REACTIVITY CONTROL SYSTEMS3/4.1.5 STANDBY LIQUID CONTROL SYSTEMLIMITING CONDITION FOR OPERATION

SERI RESPONSES TO THE JULY 21, 1989 AND
SEPTEMBER 29, 1989 NRC QUESTIONS

FIGURE 3.1.5-1 SODIUM PENTABORATE SOLUTION TEMPERATURE/CONCENTRATION REQUIREMENTS

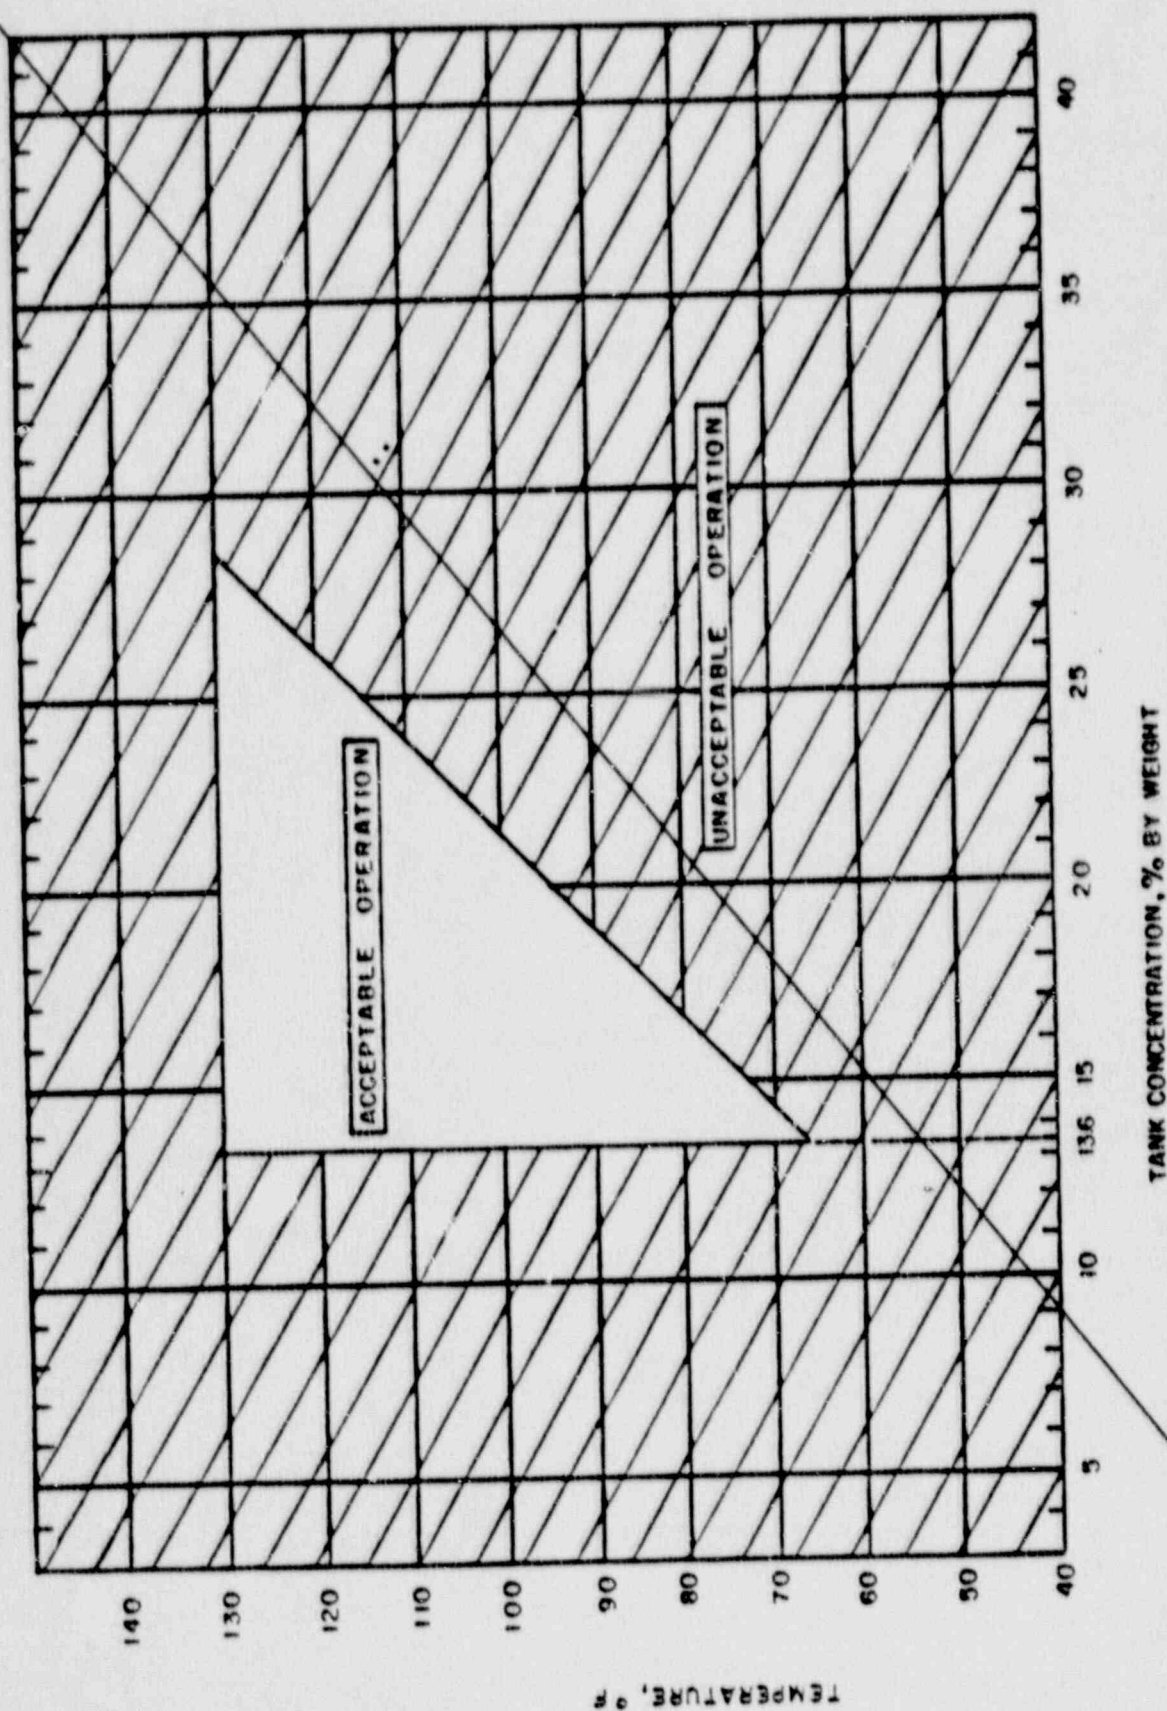
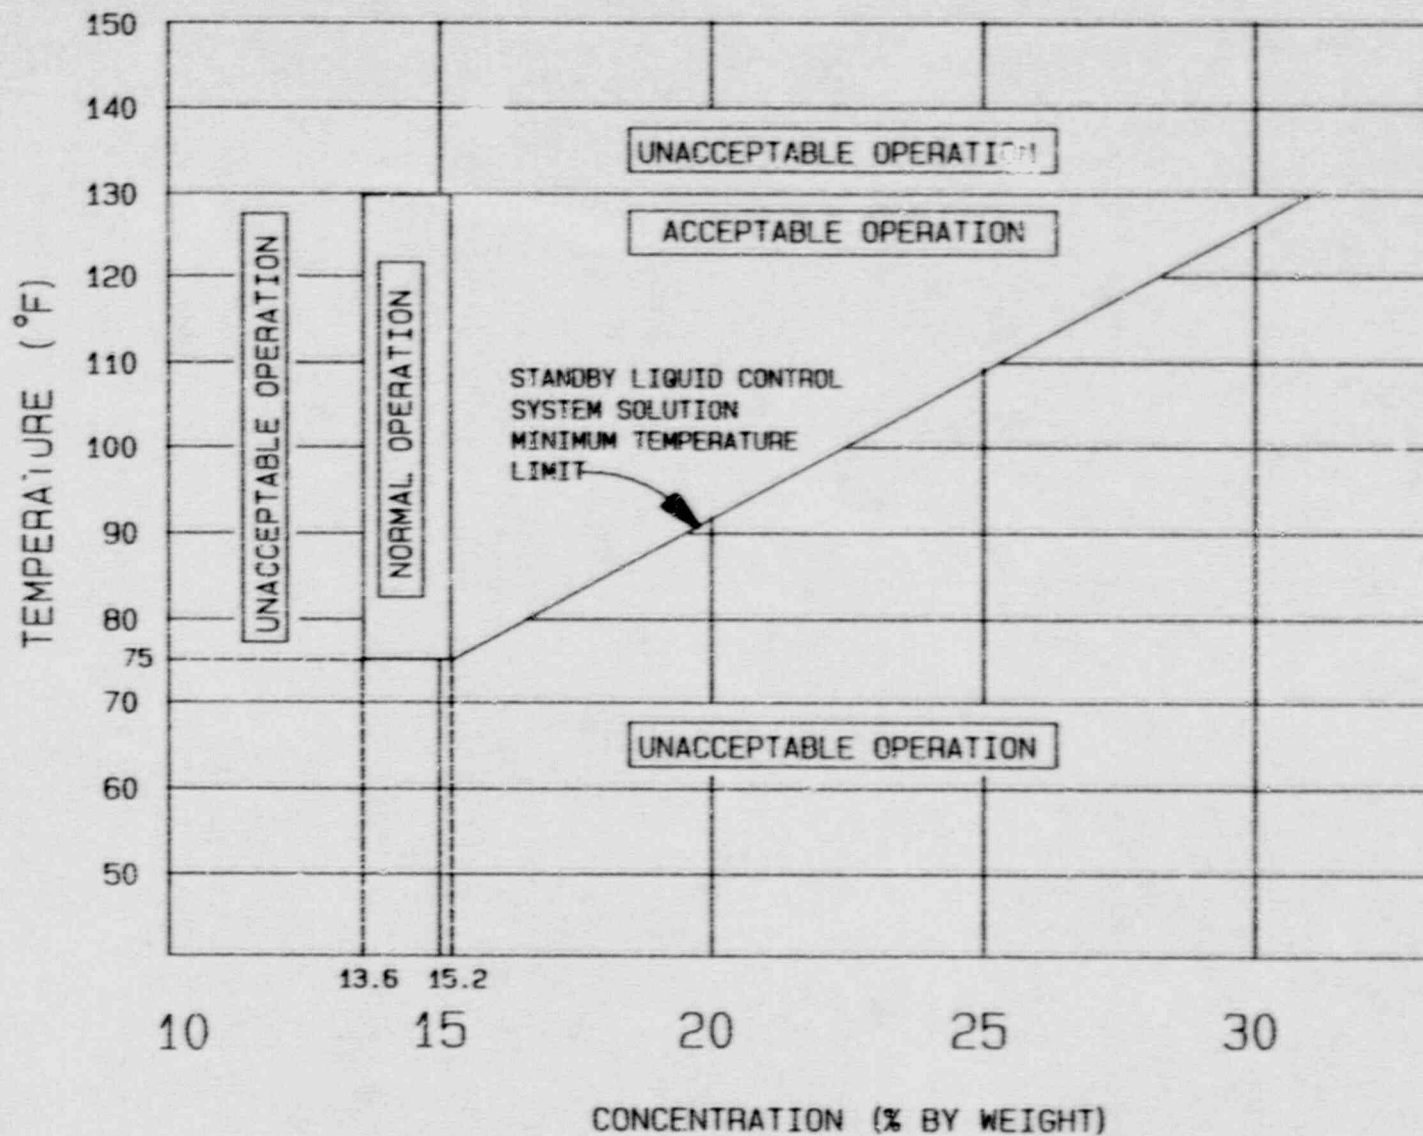
- a. At least once per 24 hours by verifying that;
 1. The temperature of the sodium pentaborate solution is ^{greater than or equal to} ~~within~~ ^{75°F and less than or equal to 130°F.} ~~the limits of Figure 3.1.5-1.~~
 2. The available volume of sodium pentaborate solution is ^{greater} ~~than or equal to 4530 gallons.~~ ^{within the limits of Figure 3.1.5-2.}
 3. The heat tracing ~~circuit~~ is OPERABLE by determining the temperature of the pump suction piping is ^{greater than or equal to 75°F and less than or equal to 130°F.} ~~within the limits of Figure 3.1.5-1.~~

*This test shall also be performed anytime water or b is added to the solution or when the solution temperature drops below ~~the limit of~~ 75°F Figure 3.1.5-1.

FIGURE 3.1.5-2
SODIUM PENTABORATE SOLUTION CONCENTRATION/AVAILABLE VOLUME REQUIREMENTS

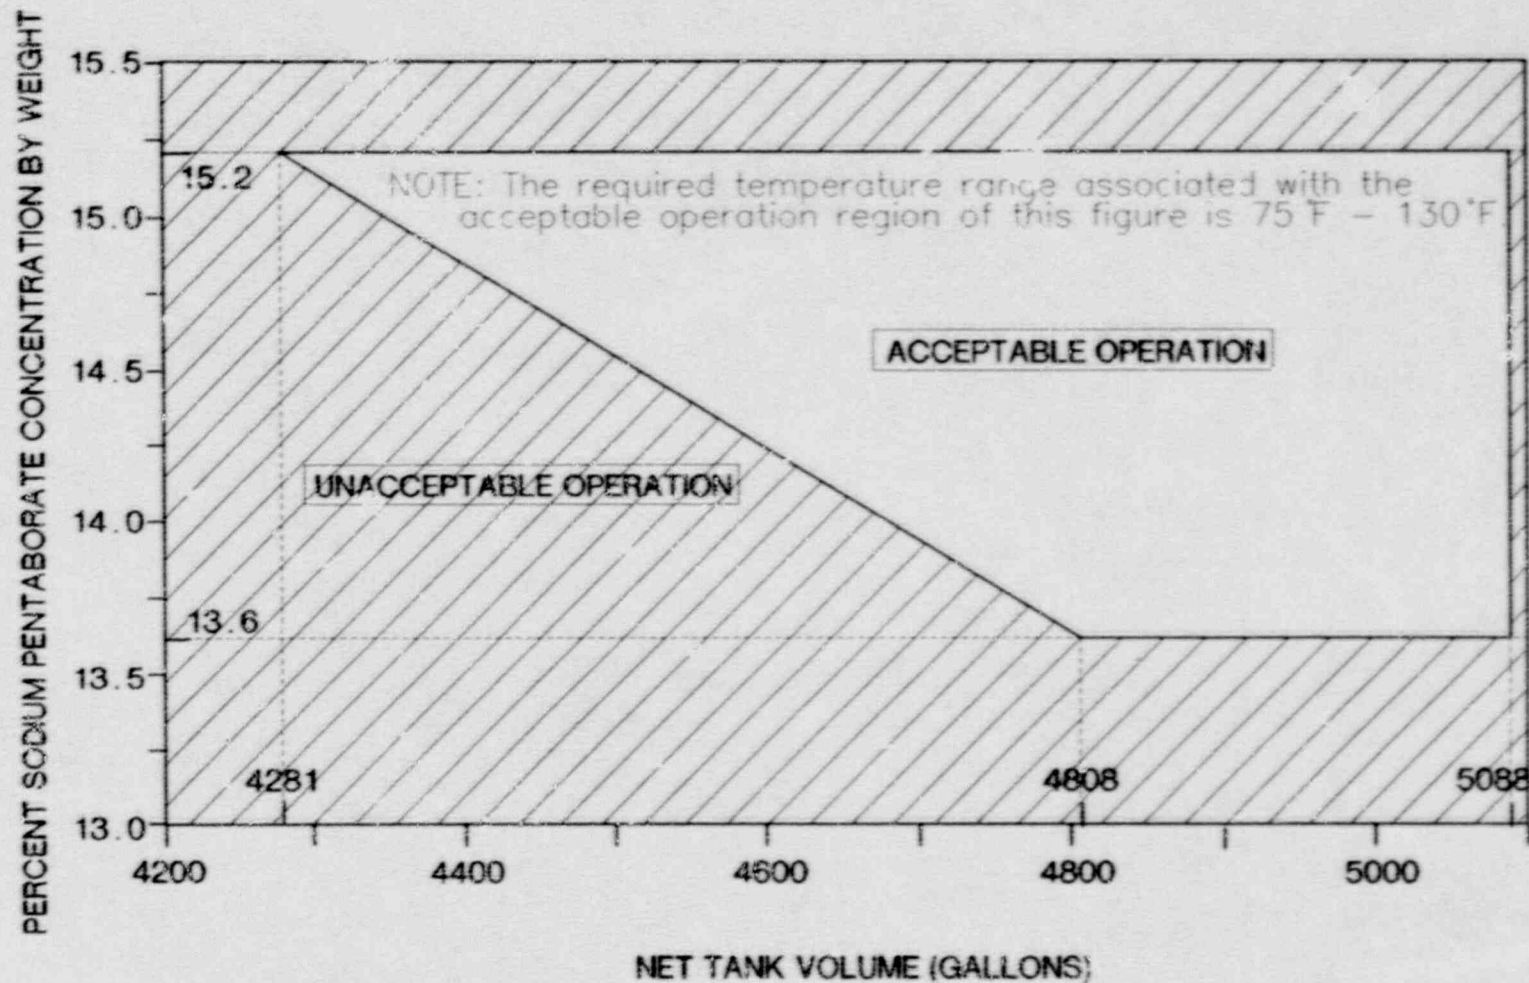
- 3. The provisions of Specification 3.0.4 are not applicable in OPERATIONAL CONDITIONS 3, 4, and 5.
- d. In OPERATIONAL CONDITIONS 1 AND 2:
 - 1. With the sodium pentaborate concentration greater than 15.2 weight percent and the net tank volume greater than or equal to 4281 gallons and less than or equal to 5088 gallons, verify the sodium pentaborate solution temperature to be greater than or equal to the standby liquid control system solution minimum temperature limit of Figure 3.1.5-1 once per 4 hours and restore the sodium pentaborate solution to within the limits of Figures 3.1.5-1 and 3.1.5-2 within 72 hours.

The sodium pentaborate solution is required to be maintained above the minimum required concentration and below the maximum allowable concentration on Figure 3.1.5-2.
